RSV – Adjustment geometry and markings

2. Technical Change

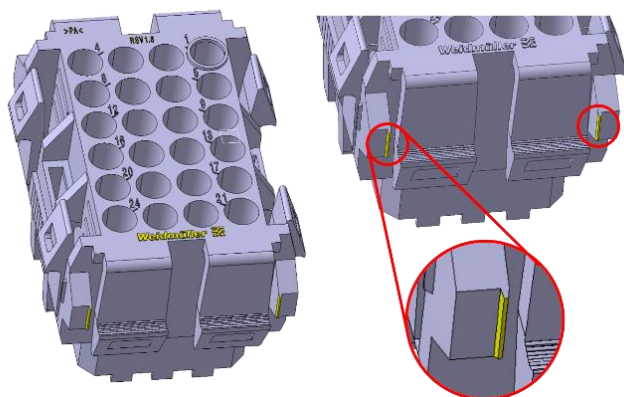
Due to product adaptations, the 24 and 36 pole RSV female and male connectors will be delivered with an adjusted geometry and markings in the future. The dimensions of the housing cutouts are not affected by this change.

Old version

New version
